City of Albuquerque

RE: ENGINEER CERTIFICATION FOR SUN HEALTH CARE PHASE III (D17/D3Y)
CERTIFICATION STATEMENT DATED 10-22-98

RE: CONCEPTUAL G & D PLAN FOR SUN HEALTH CARE PHASE 3 (D-17/D3Y)
RECEIVED AUGUST 20, 1996 FOR SITE DEV PLAN FOR B.P.
ENGINEER'S STAMP DATED 8/16/96

SUN HEALTHCARE PHASE 3
DRAINAGE REPORT

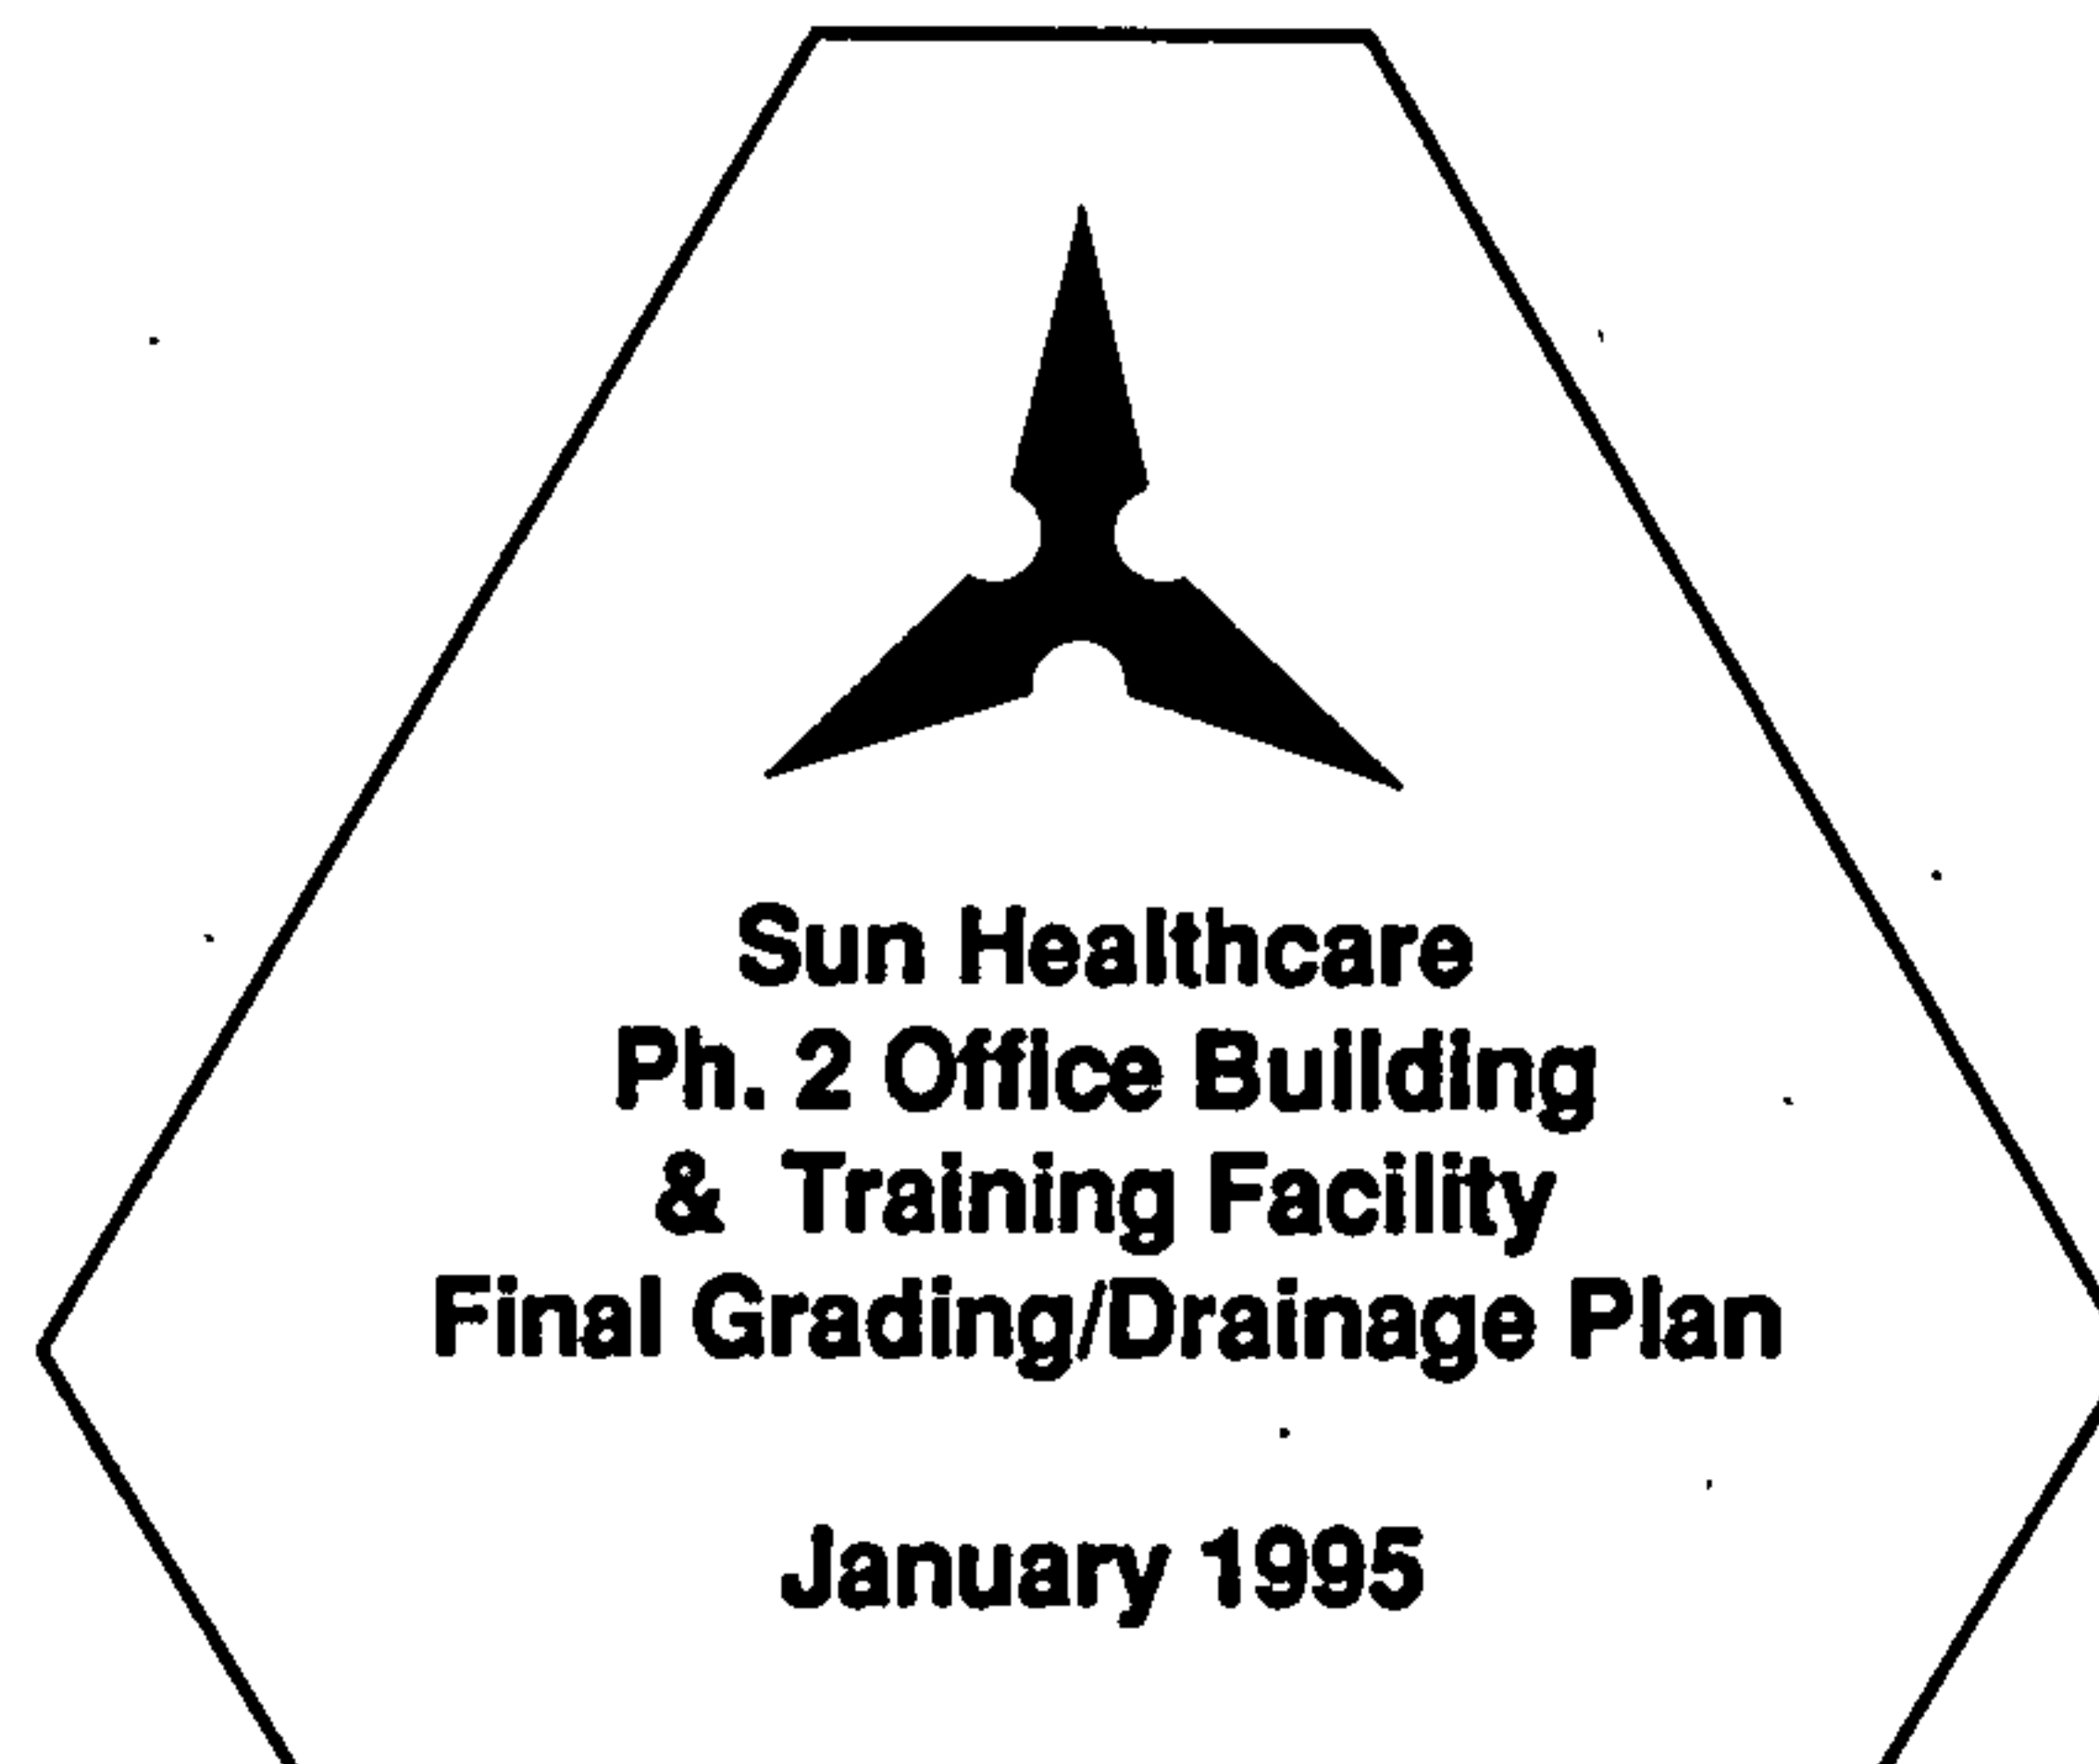
The following comments must be addressed before Building Permit approval:

1. Indicate roof drain location on the Drainage Plan. This will determine the boundary between basin B & B-1.
2. Indicate height of curbs. Curb height is assumed to be 6". The 53.03 TC elevation across from inlet 1 appears to be lower than the 54.4 grate elevation. Work Order plans for Sun Lane do not include the west entrance to the site.
3. Obtain a License from AMAFCA before doing any work within the North Pino Arroyo right of way. Since the bridge is part of this project, AMAFCA must approve the bridge before City Hydrology can approve this project for Building Permit.
